**Proposal #07: 5300-02-73, WISC 2016 343
West Madison Beltline
High Point Structure & Apprs
USH 12
Dane County**

This is Addendum No. 01, which provides for the following:

ADDENDUM NO. 01

GENERAL PLAN

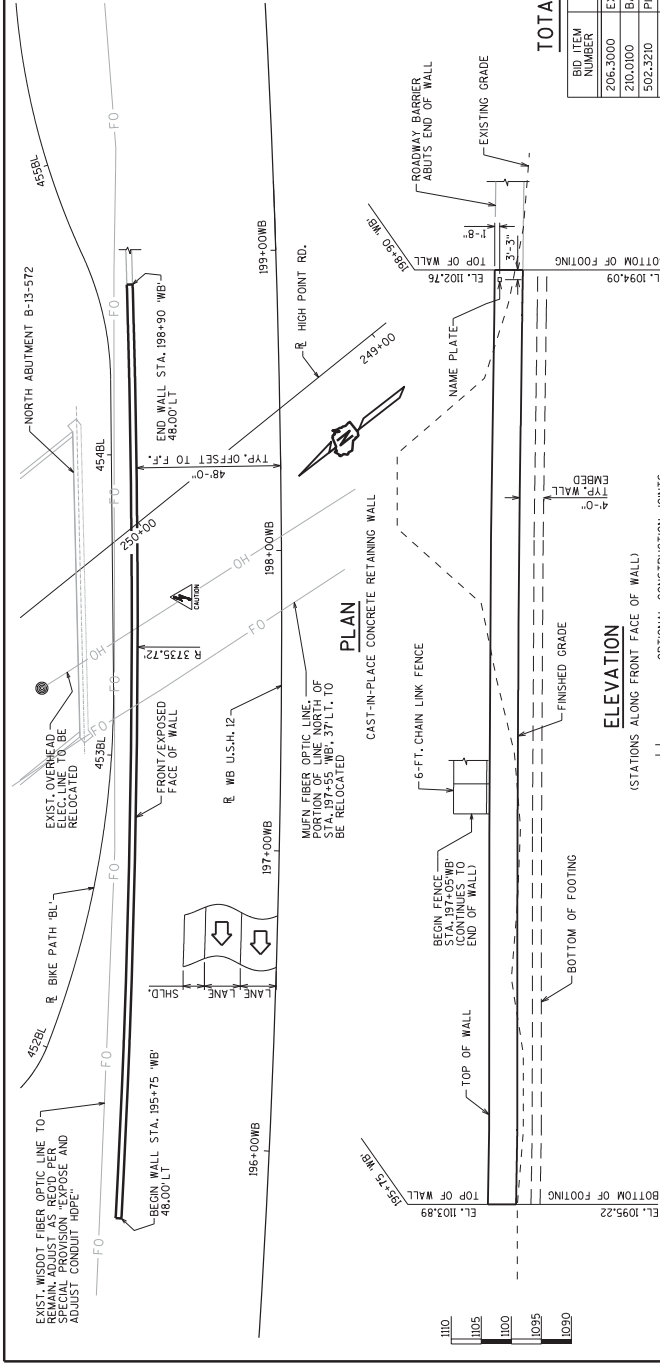
Revised Plan Sheets	
Plan Sheet	Plan Sheet Title (brief description of changes to sheet)
66	Miscellaneous Quantities (Added tables for Removing Guardrail and Removing Fence).
71	Miscellaneous Quantities (Revised table to remove the note indicating "Additional Quantity Found in Structures Plans" for item 616.0206 Fence Chain Link 6-Ft.).
264	Structure R-13-255 General Plan (Changed bid item in Total Estimated Quantities table from "616.0206 Fence Chain Link 6-Ft" to "SPV.0090.06 Fence Chain Link 6-FT. R-13-255").
265	Structure R-13-255 Fencing Details (Changed Note 4 under General Notes to read "The Bid Item Shall Be 'Fence Chain Link 6-FT. R-13-255', LF.").
